Access Compliance Report Public Rights-of-Way (Pedestrian Signals)

Main Street: **BROWNING_AVE** Cross Street: **IRVINE_BLVD** Location: **SE**

ADA ID: **SGRK211006110338** Signal Type: **One Push Button-APS** Overall Compliance: **No** Severity Scores: **BTN 1: 25** **BTN 2: N/A** **No BTN: N/A**

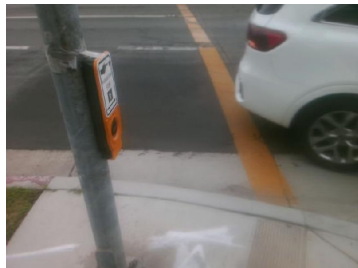
OC Std/PROW: **R404.2**

Possible Solutions: Remove and Replace Clear Space.
